Work Order ID 148812

Item Name: Quick Release Heli-Utility-Basket™ Long, HD Lid, Spacepod™/Squirrel Cheek Comp.

TO AMEND INSTALLATION INSTRUCTIONS D350-607-3 Rev.D,
INSTALLATION INSTRUCTIONS D350-607-4 Rev. C AND
INSTRUCTIONS FOR CONTINUED AIRWORTHINESS ICA-D350-607 REV. 6
REF TCCA STC: SH94-14
REF FAA STC: SR00213NY
REF EASA STC: EASA.10016996
REF BRAZILIAN STC: 2007S03-03/-04/-05/-06

A	NEW ISSUE	AJS	14.05.16
REV.	DESCRIPTION	BY	DATE
DESIGN	AJS	DART AEROSPACE LTD	
DRAWN	AJS	HAWKESBURY, ONTARIO, CANADA	
CHECKED	N/A	DRAWING NO.	REV. A
MFG. APPR.	N/A	DSI 9699	SHEET 1 OF 2
APPROVED		TITLE	SCALE
DE APPR.		LUG REPLACEMENT	NTS
DATE	14.05.16	COPYRIGHT © 2014 BY DART AEROSPACE LTD THIS DOCUMENT IS PRIVATE AND CONFIDENTIAL AND IS SUPPLIED ON THE EXPRESS CONDITION THAT IT IS NOT TO BE USED FOR ANY PURPOSE OR COPIED OR COMMUNICATED TO ANY OTHER PERSON WITHOUT WRITTEN PERMISSION FROM DART AEROSPACE LTD.

FIGURE 1: INSTALLATION OF D4775-041 FWD STRUT

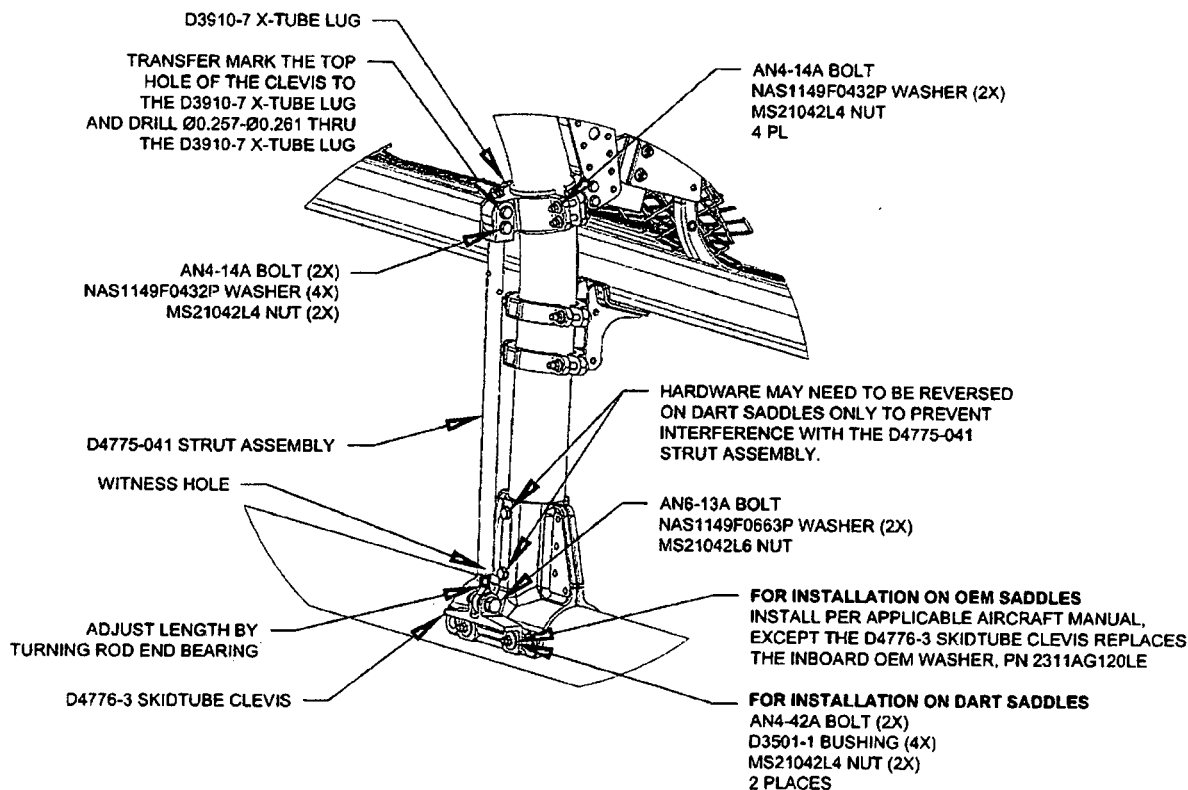
Install the D350-607-501 Conversion Kit, D350-607-511 Quick Release Mounting Kit or D350-607-431 Strut retrofit kit per Installation Instructions D350-607-3 Rev. D or D350-607-4 Rev. C. While installing the Forward Strut perform the following:

- 3.1 Substitute the Forward Lower D3910-5 X-Tube Lug with the D3910-7 X-Tube Lug as shown in Figure 1.
- 3.2 Install the forward D4775-041 Strut Assembly. Transfer mark from the upper hole on the clevis of the D4775-041 Strut Assembly to the D3910-7 X-tube Lug and drill thru the lug $\varnothing 0.257$ - $\varnothing 0.261$ as shown in Figure 1. Touch up chemical conversion coating per MIL-DTL-5541. Check the witness holes located at the bottom end of the D4775-041 Strut Assemblies to ensure that the thread from the rod end extends past the witness hole.
Torque MS21042L4/-4 nuts to 50-70 in-lbs (5.7-7.9 N-m). Torque MS21042L6/-6 nuts to 160-190 in-lbs (18.1-21.5 N-m).
- 3.3 Complete the installation in accordance with Installation Instructions D350-607-3 Rev. D or D350-607-4 Rev. C.
